From: [REDACTED]
To: [REDACTED]
CC: [REDACTED]
Sent: 2/24/2021 7:26:26 AM
Subject: RE: O8W-PM 35217268, 35224712, 35224713 - Bucks Creek 1101 Phase 1,2&3 - Pre-Engineering Meeting

PM 35217268 (Phase 1)

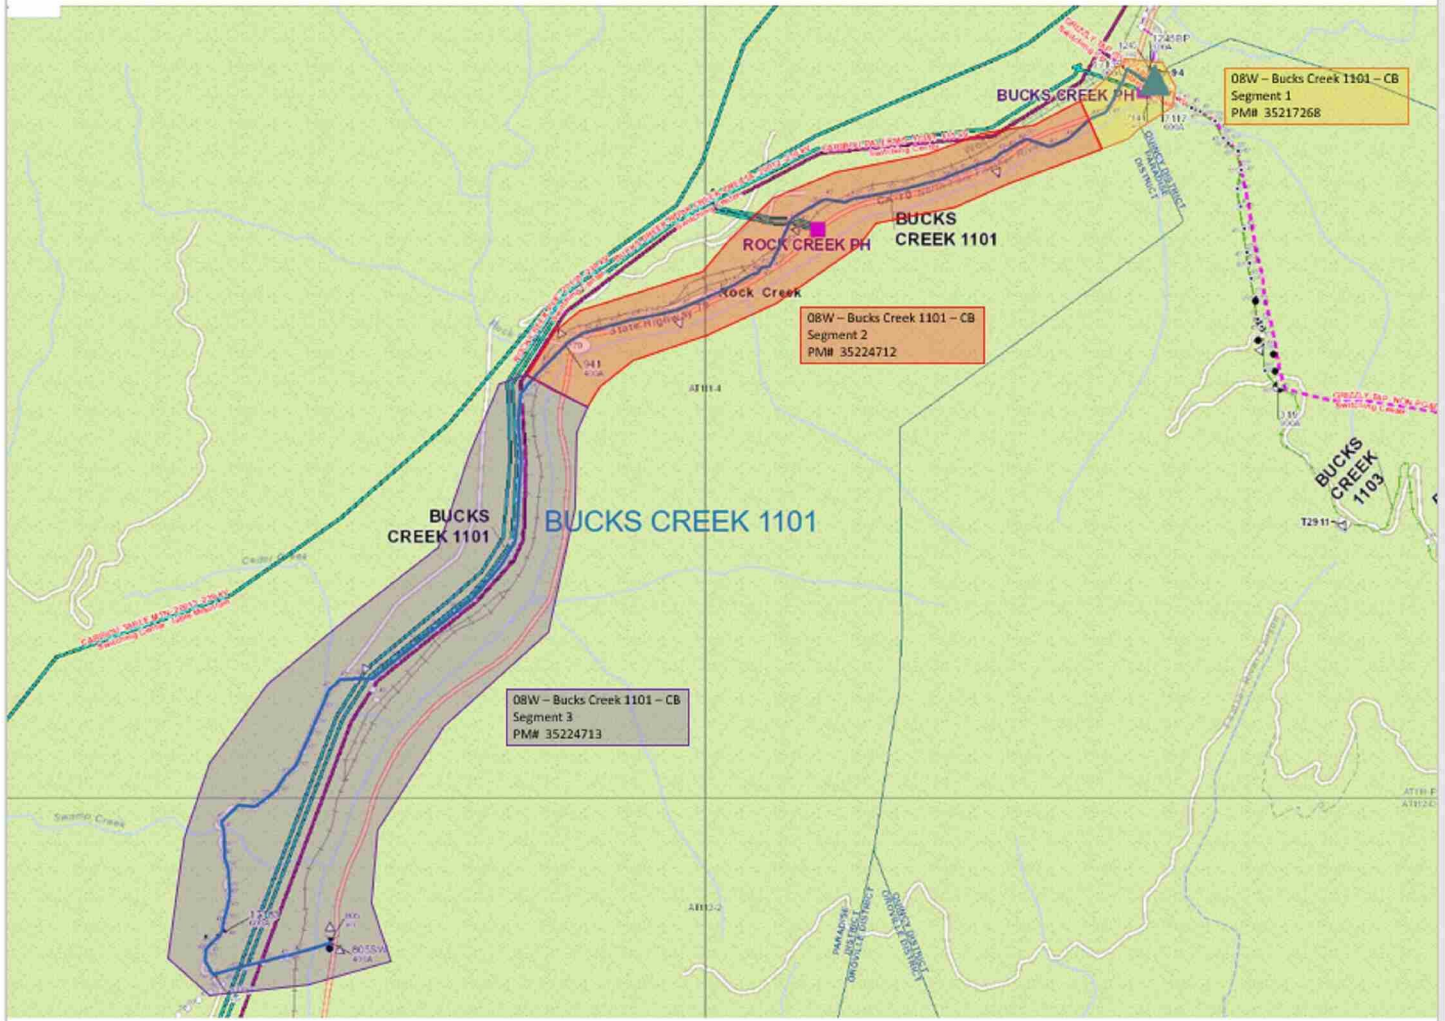
Attached are the 'base-map' limits in a kmz. file. As you will see, we need our base-map to go about ~100' into the tunnel at the south end (see pedestal in picture below....please begin about ~50 beyond this point which is about ~100' beyond the Cresta Dam).

We want to end the base-map at the sign location below which is roughly at MM (Mile Marker) 5.10.
